Monticello Nuclear Generating Plant
Docket No. 50-263
Renewed Facility Operating License No. DPR-22

Subsequent License Renewal Application Response to Request for Additional Information and Request for Confirmation of Information - Set 1 Part 2

RAI GW-5 Groundwater

**FIGURE 2
 WELL LOCATIONS
 (08/18/2023)**

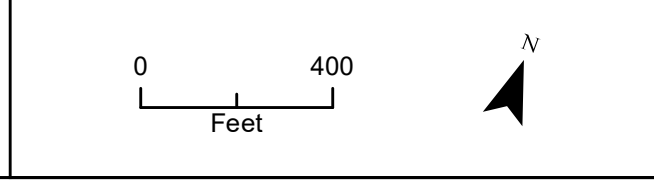
REQUEST: Provide a narrative description of the detection and response to the inadvertent release(s) of tritium into groundwater (first reported in November 2022) through August 18, 2023. This description should include, but not be limited to, the following information:

Figure 2 – Well Locations and Figure 3 – Detail View – show the location of the new monitoring wells and tritium recovery wells that have been installed as of August 18, 2023.

FIGURE 4 SHEETPILE WALL AND GRADIENT CONTROL SYSTEM

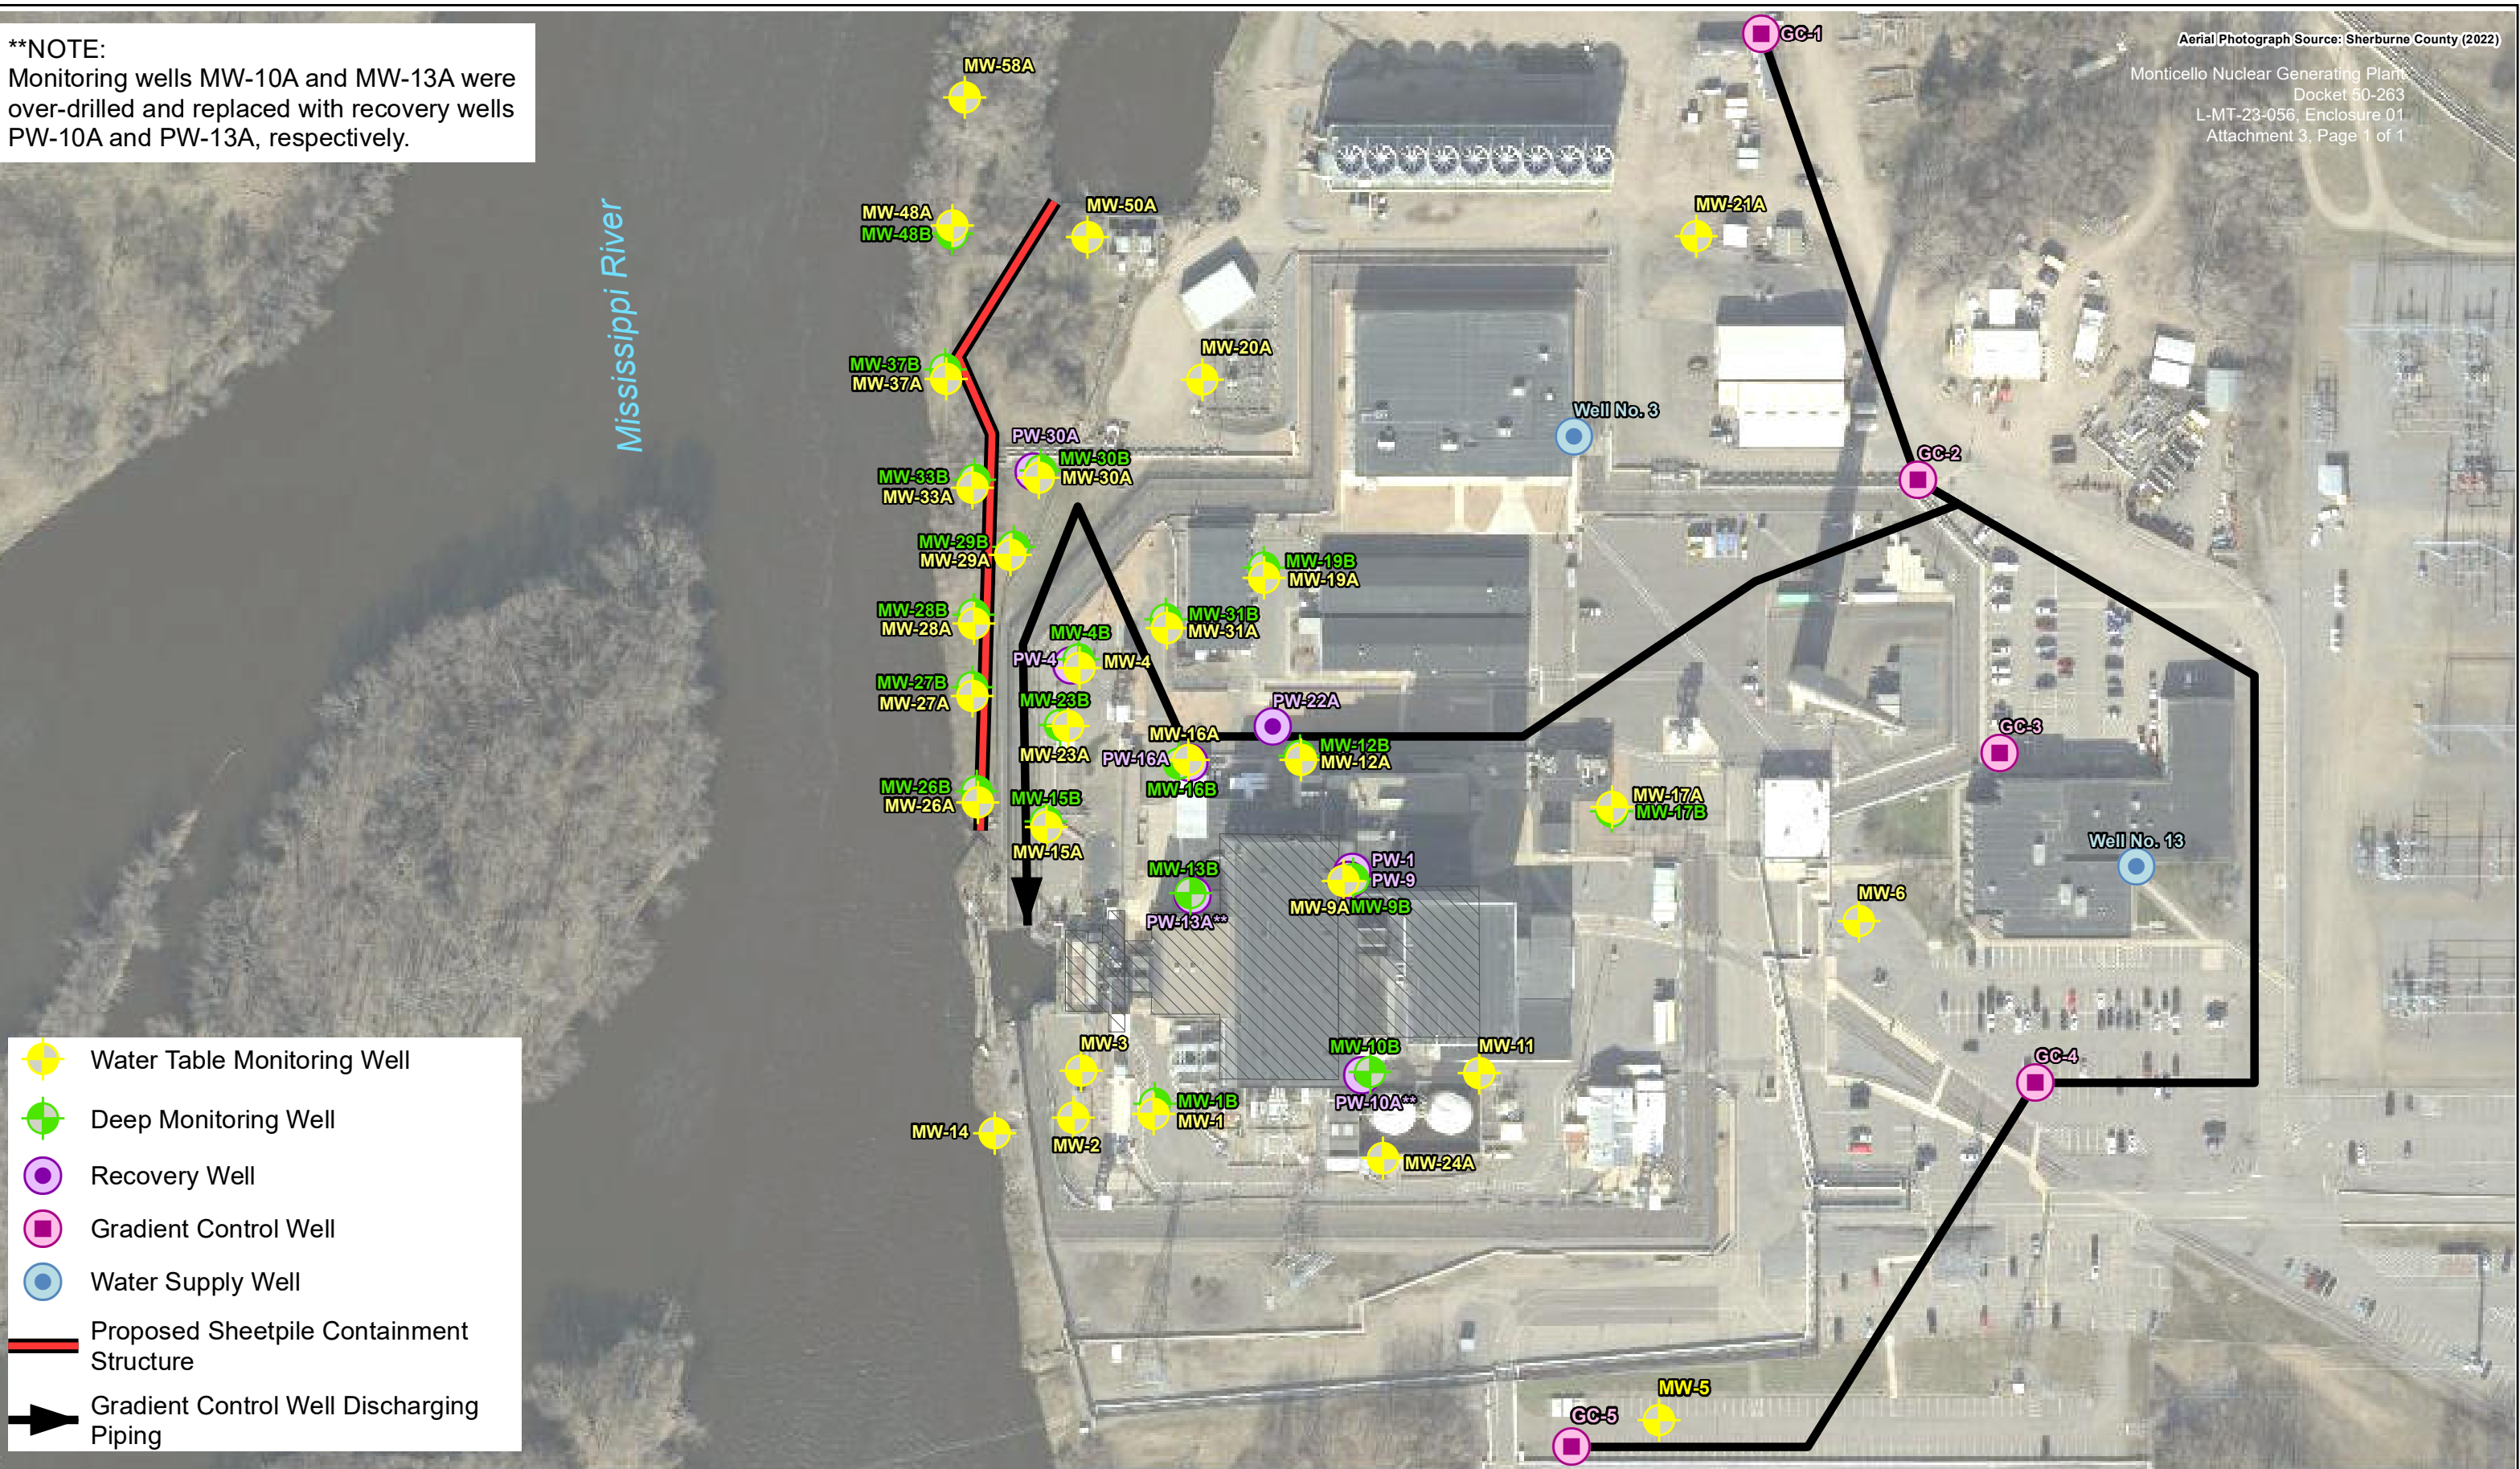
- (g) A description of the current plan, subject to change, for remediation/mitigation of the groundwater tritium contamination, including:
 - location of the cutoff wall,

- locations of hydraulic control pumping wells,
 - estimated pumping rates of the hydraulic control pumping wells,
 - disposition of the water pumped for hydraulic control,

- criteria to terminate pumping of tritium recovery wells and hydraulic control wells, and
 - estimated time to remediate the tritium contamination.

As of August 18, 2023, Figure 4 shows the approximate location of the sheetpile containment structure (cutoff wall) and the proposed approximate location for the gradient control wells and discharge piping.

The estimated pumping rates for the gradient control wells are 100-200 gallons per minute. The rates will adjust based on river level and hydraulic conditions at the station (i.e., drought versus flooding). The gradient control wells will be issued a water appropriation permit by Minnesota Department of Natural Resources. The gradient control wells will likely be discharged into the intake as shown in Figure 4.
